TECHNICAL NOTE

PROJECT	:	Land adjacent Sefter School House, Sefter Road, Pagham
NOTE REF.	:	Acl640/21023/TN
NOTE TITLE	:	Additional Information requested by the LLFA
AUTHOR	:	Tafari Lewis
APPROVED	:	Tafari Lewis
DATE	:	11 th March 2022

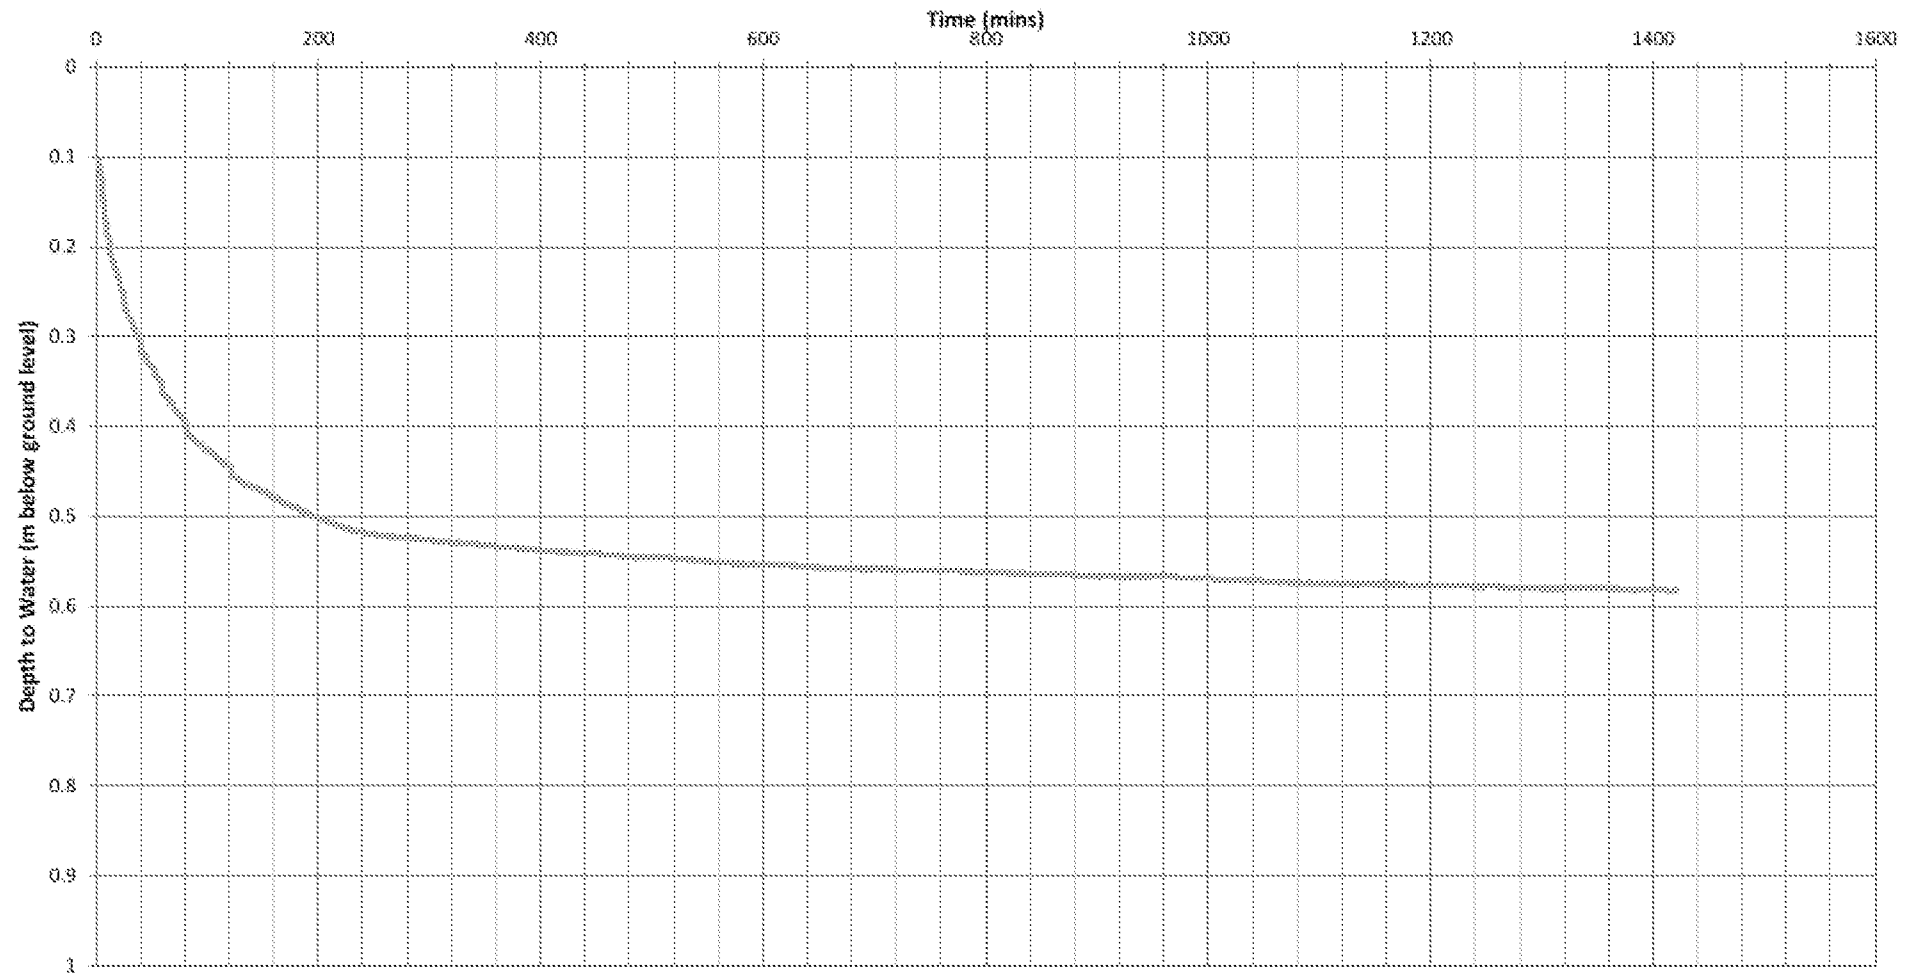
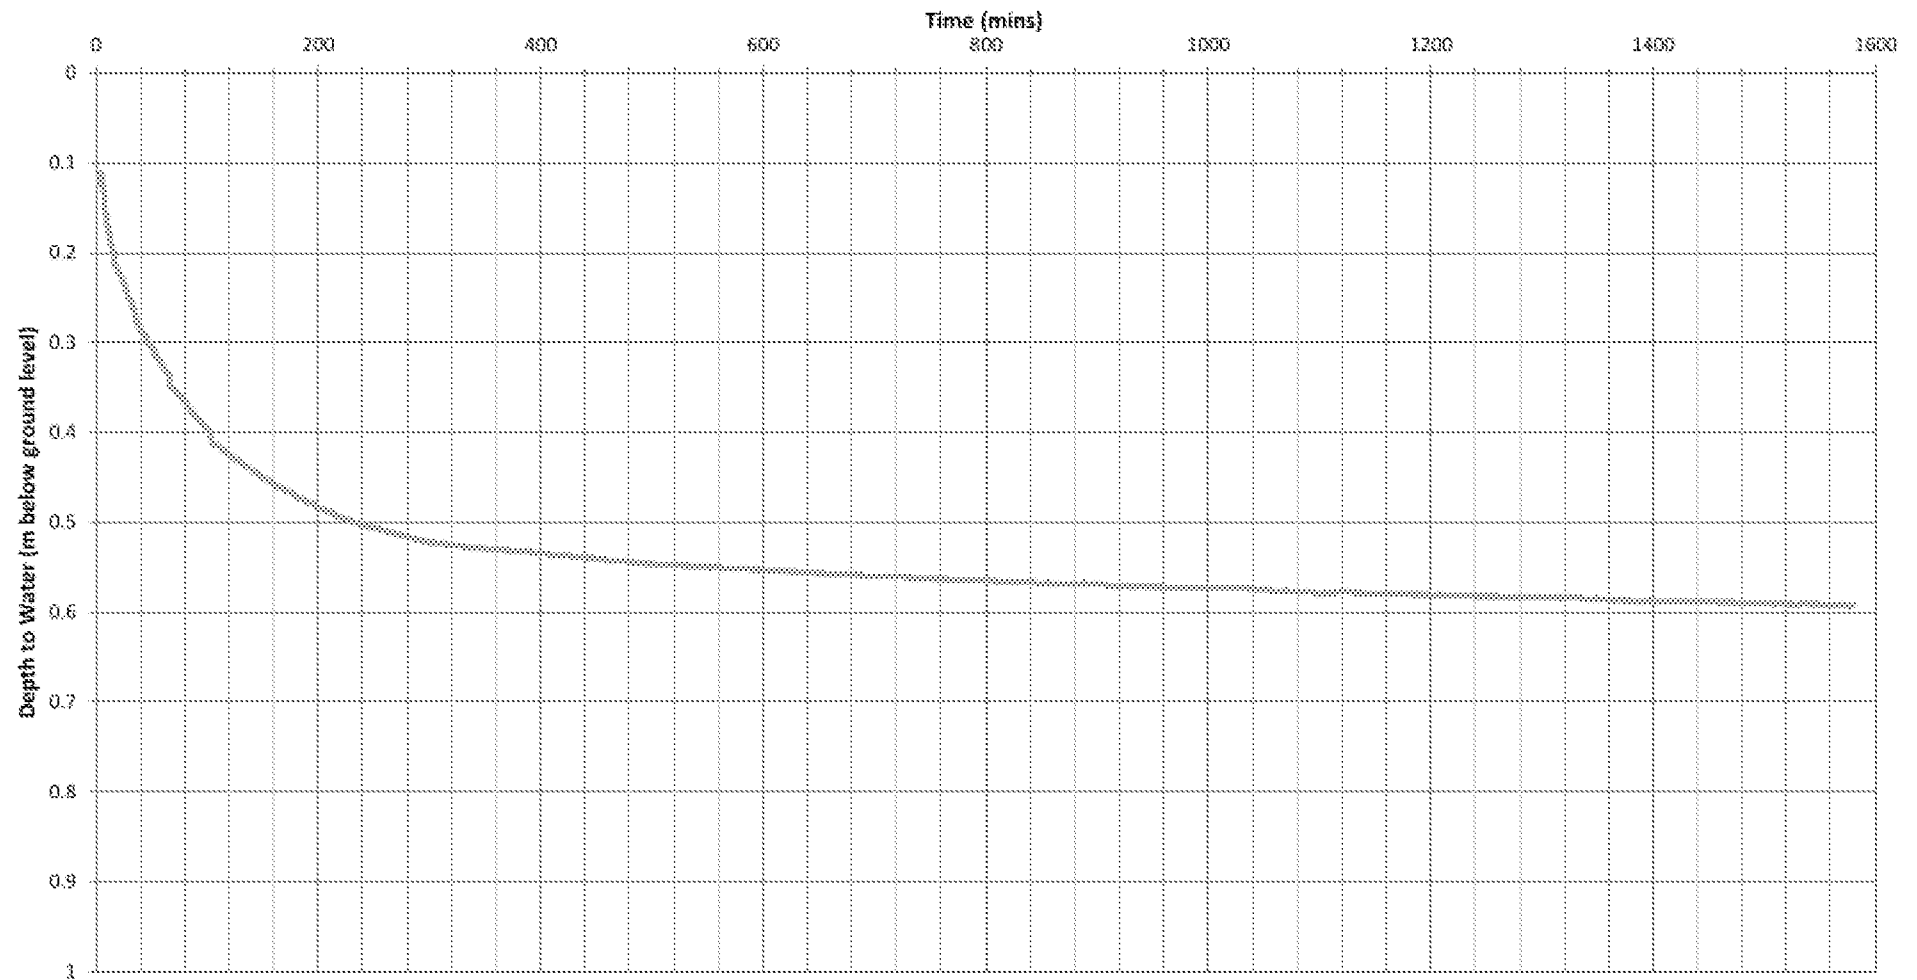
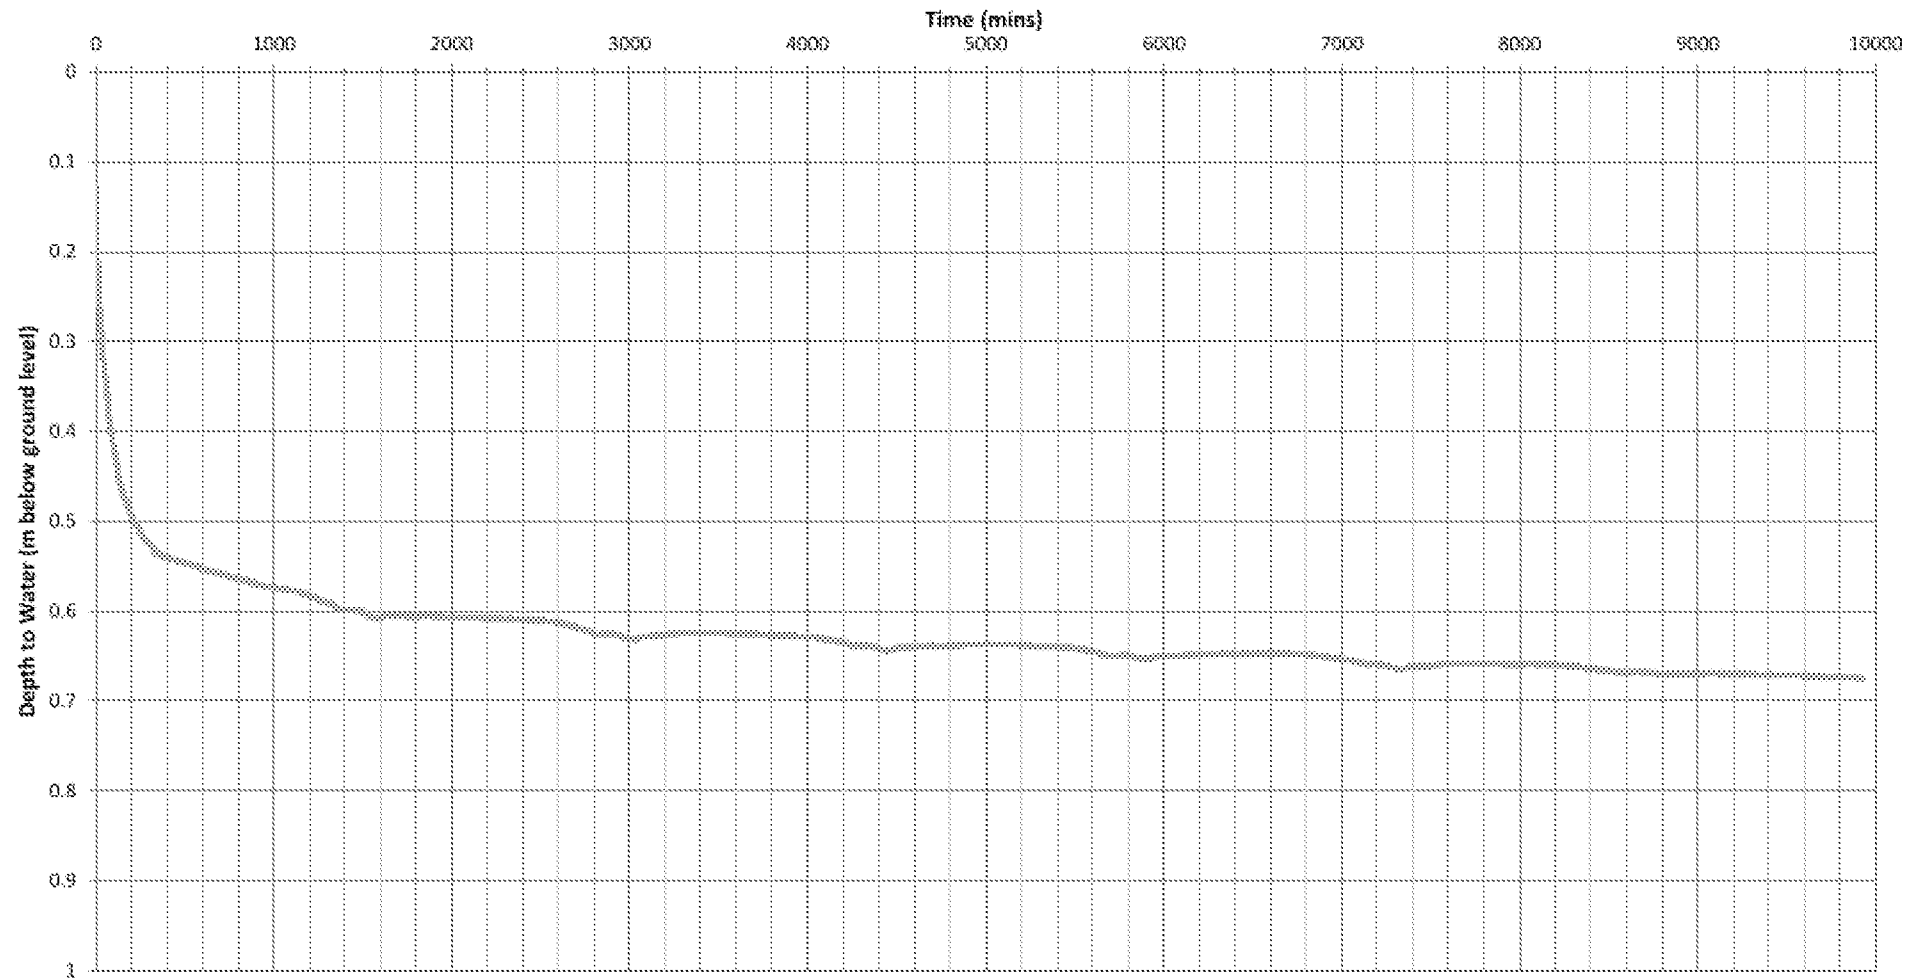
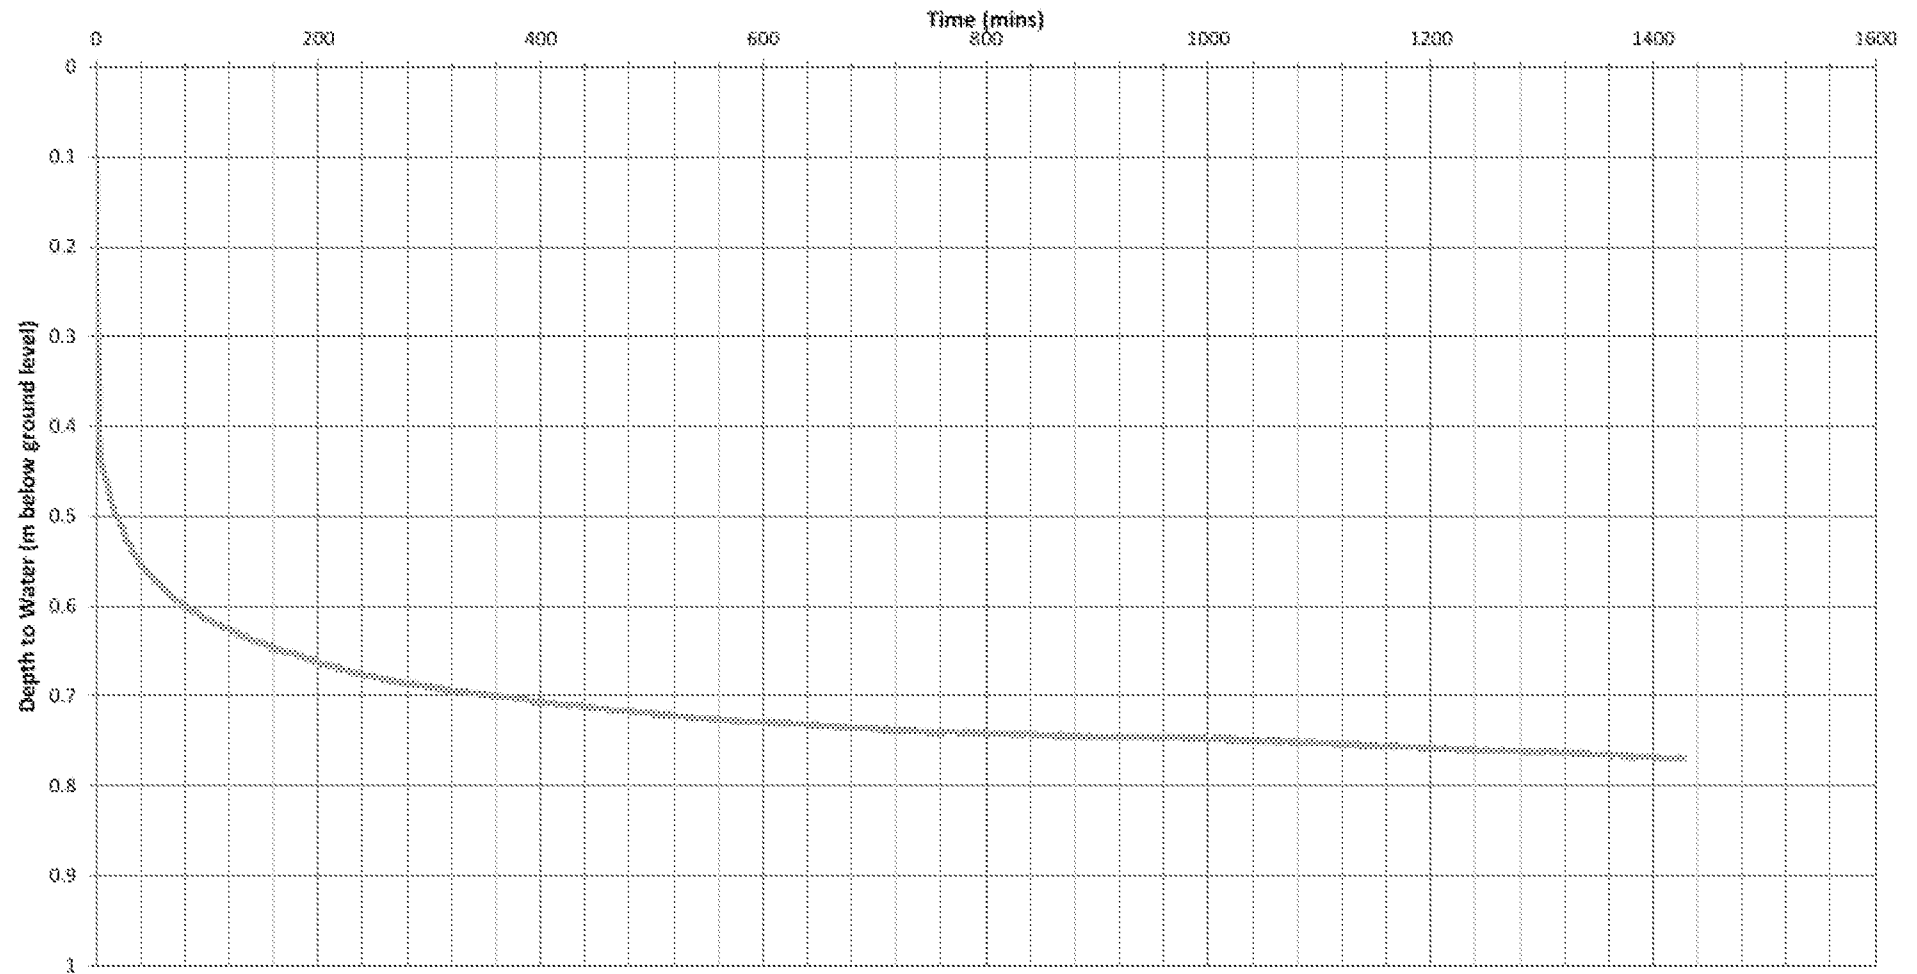
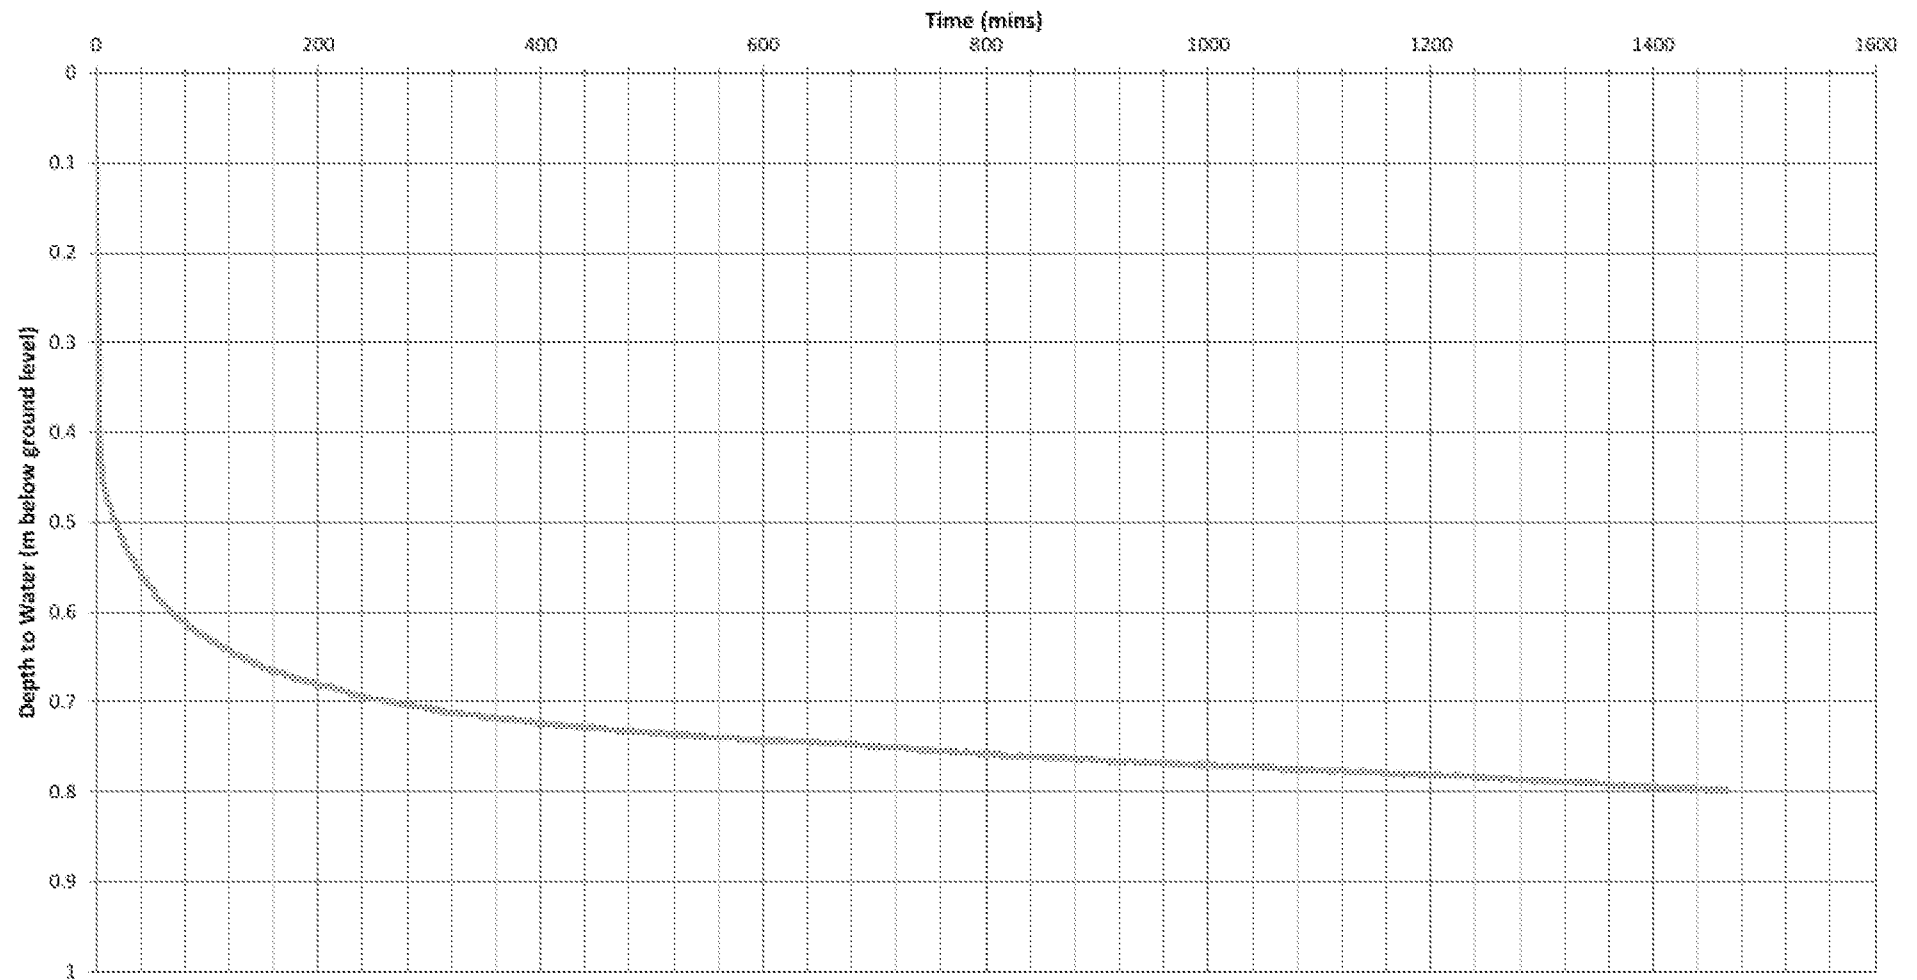
"No winter infiltration testing has been completed. It is considered that infiltration is unlikely to work here, however this should be supported by on site infiltration testing."

Refer to Ashdown Site Investigations Ltd infiltration testing report in **Appendix B**.
